County of Fairfax, Virginia

June 29, 2012

Re: Interpretation for RZ/FDP 2009-SU-024, PCA 2003-SU-035,
SEA 2003-SU-023, Dulles Discovery South, Tax Map 34-2 ((1)) 2 pt., 3A, 7, 8,
10A, 27 pt., 35 pt.: Building Addition, Building and Layout Modifications,
Road Improvements, Security, Landscaping and Parking

DULLES DISCOVERY SOUTH
VIEW FROM CENTREVILLE ROAD
MARCH 7, 2012

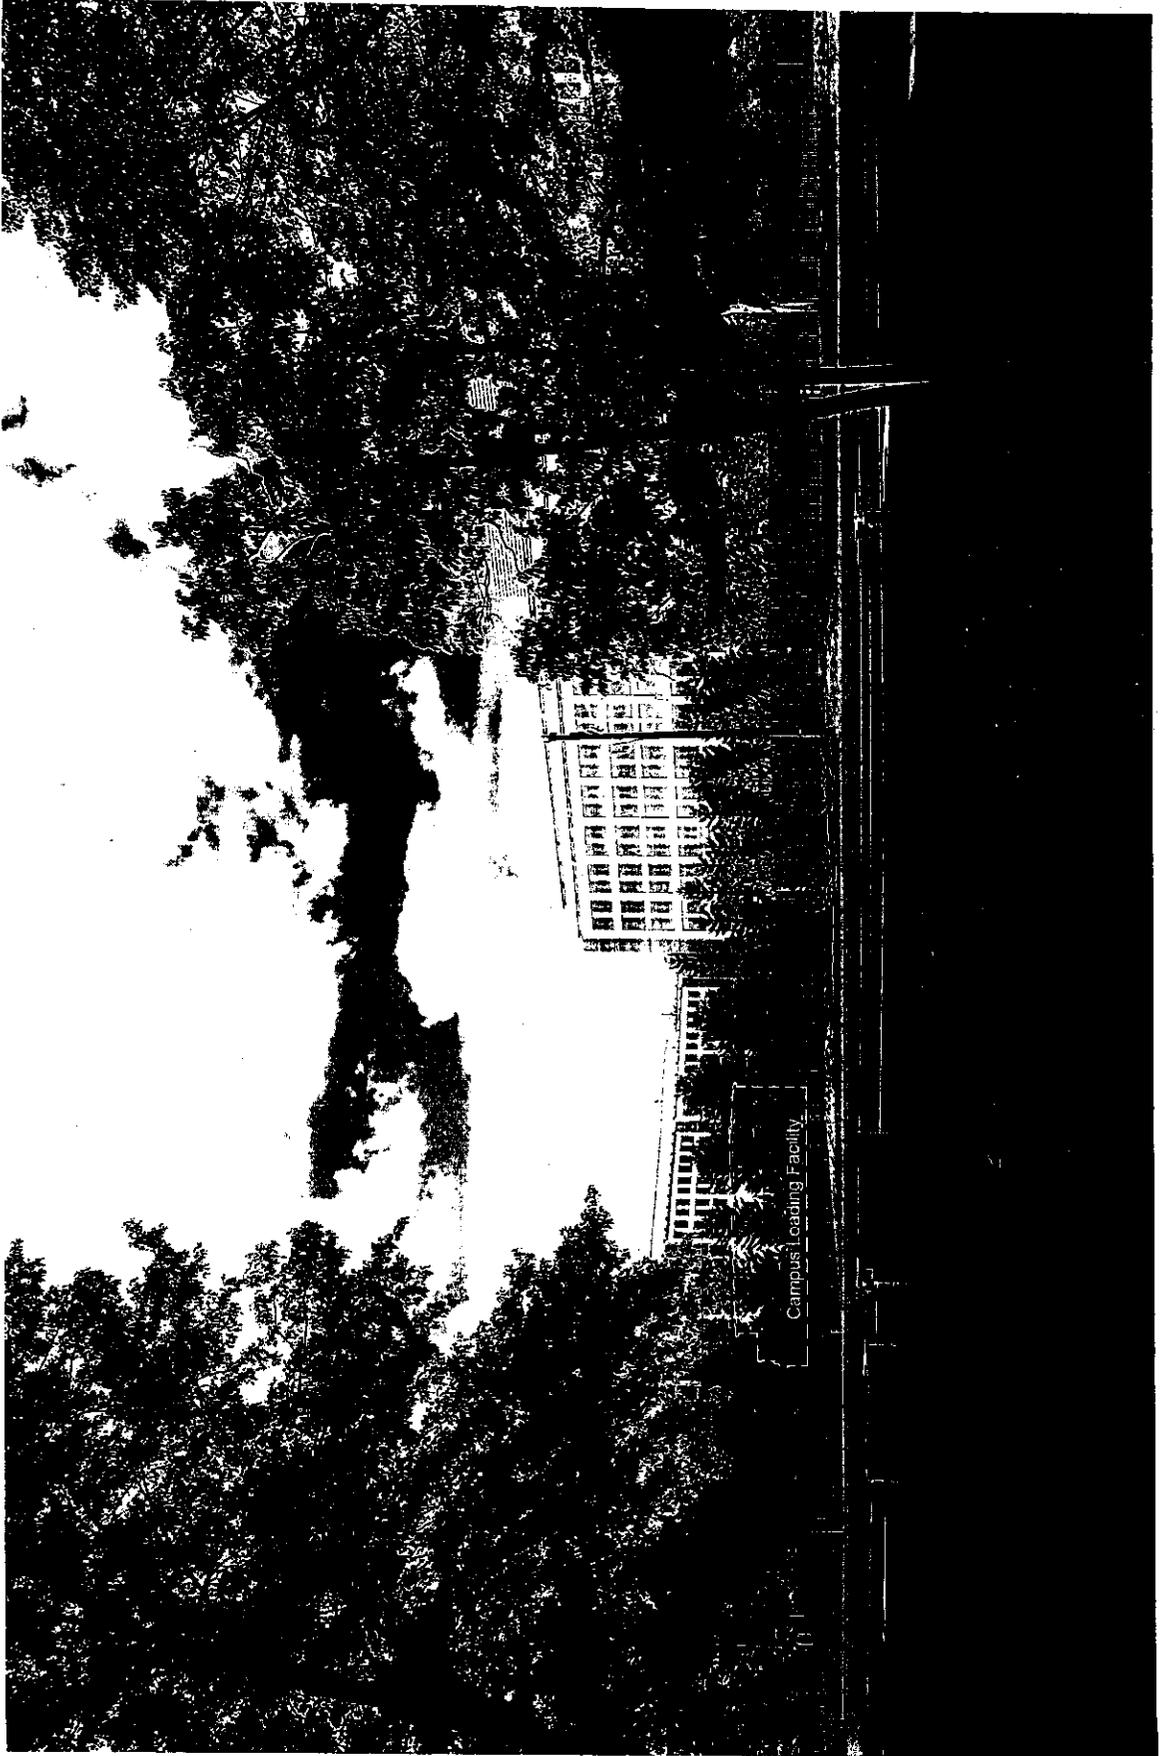
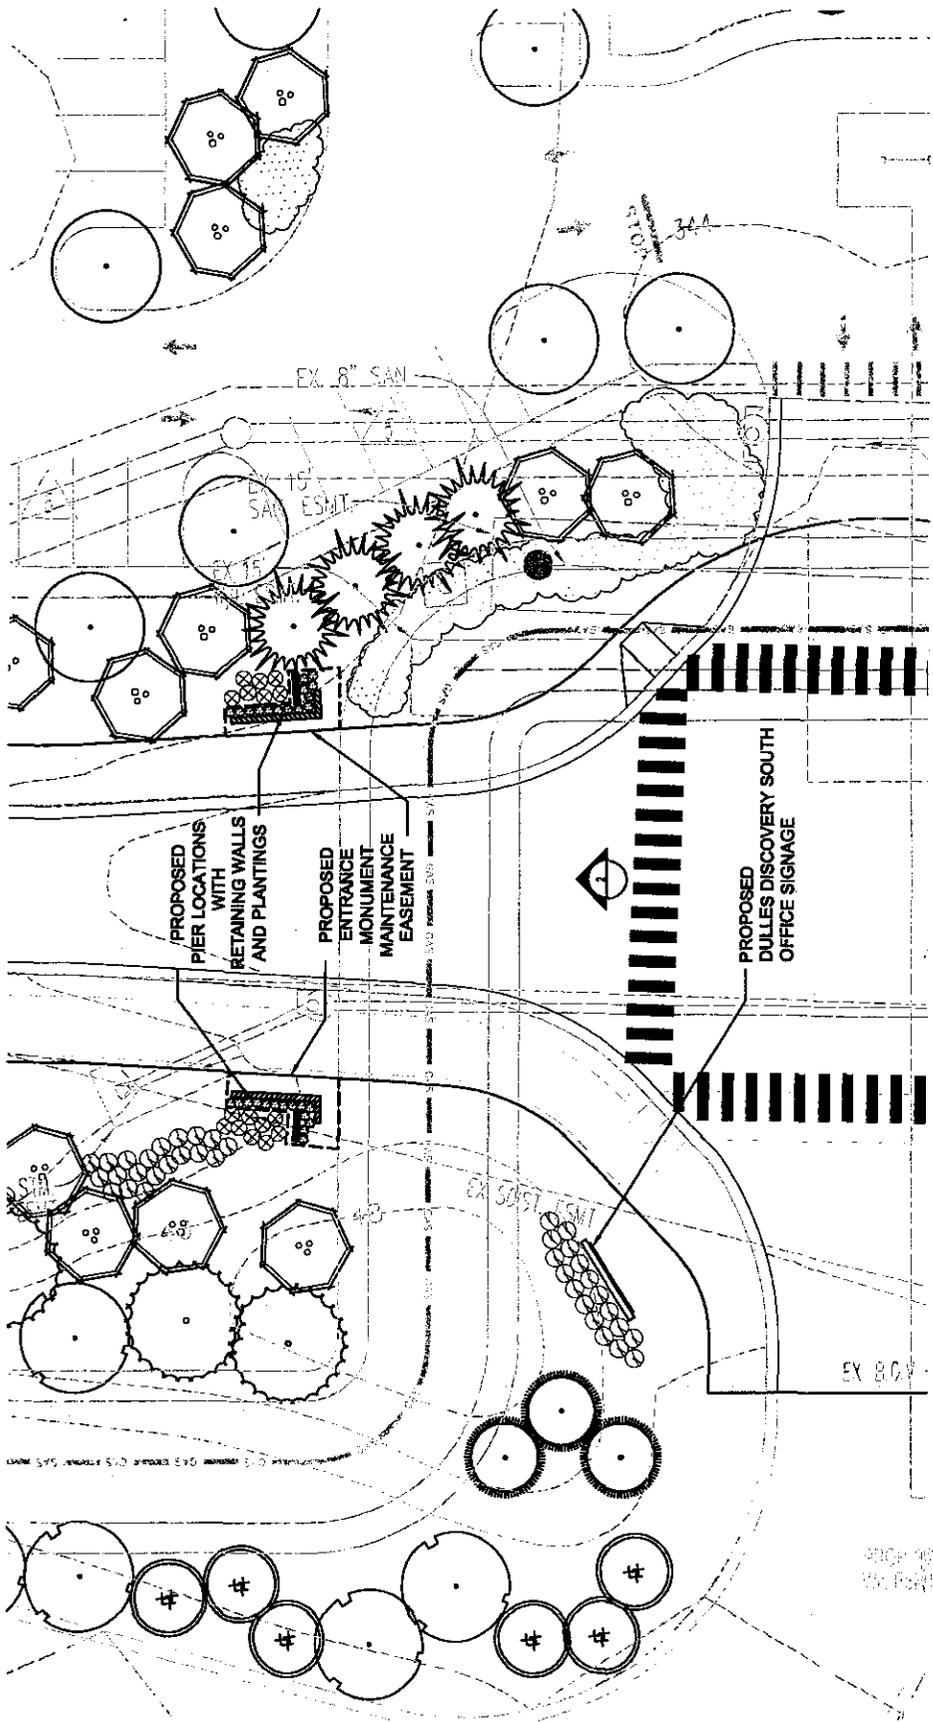
The proposed CLD would be located approximately 563 feet from Centreville Road. You indicate that the CLD would be screened by the future East Parking garage shown on the approved CDP/FDP, as illustrated in the sight line analysis in Attachment 7. However, construction of the parking garage is not planned at the present time. In the interim, prior to the construction of the garage, you indicate that the CLD would be screened to the east by the berming and landscaping approved as part of the March 2011 interpretation, as illustrated in Attachments 12A and 12B. No landscaping is shown in the interpretation exhibits around the foundation of the CLD.

It is my determination that the proposed CLD building addition, the revised MIF, and the shifting of floor area from the Central Plant, as described above, would be in substantial conformance with the proffers, CDP/FDP, SEA Plat and development conditions, provided that the proposed cellar is designed, engineered and constructed to meet the definition of cellar, as determined by DPWES; provided that supplemental landscaping is installed around the foundation/perimeter of the CLD to soften the structure's appearance, and in the buffer along Centreville Road, if needed to adequately screen the CLD from Centreville Road, as determined by Urban Forest Management Division

Attachment 15(A)
(Revised 5/23/12)

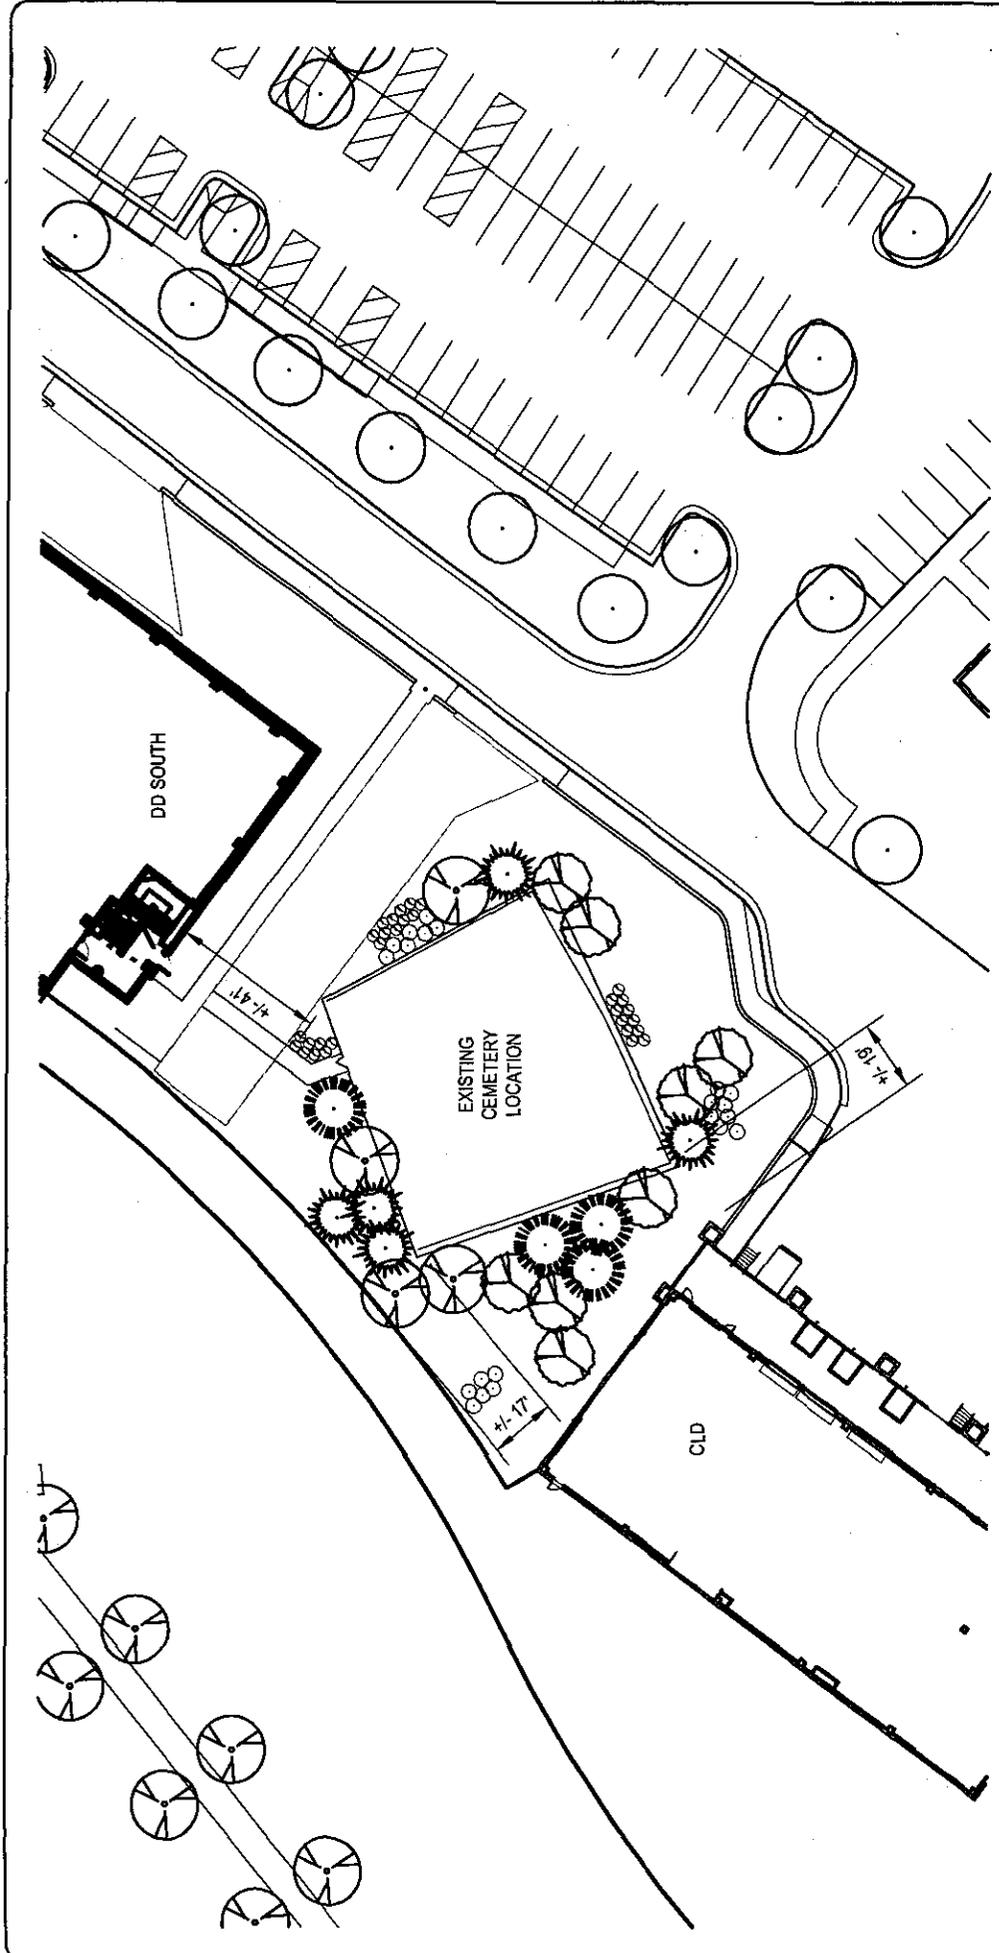
The roundabout shown in the approved zoning served as a traffic calming measure. To maintain this function, the applicant proposes to provide signalization of the intersection, subject to warrants being met and VDOT approval. The FCPA has requested that the intersection and signalization be designed to maintain the saliency of access to the Sully Historic Site. This concern should be addressed in the ultimate signalization software and in the interim in the design of an intersection that may not be signalized for a period of time. In that instance, the FCPA has requested that the proposed intersection be designed to allow free flow movement through the intersection on Historic Sully Way. Such movement is critical to accommodate large events held at the Historic site. Pedestrian crossings are also proposed to be provided, shown in Attachment 15 (A) as painted crosswalks.

The pedestrian crosswalks, in lieu of the Roundabout, have also been shown on Attachment 15A (Revised). Attachment 15(B) (Revised) simply has the revision date of May 23, 2012 added.
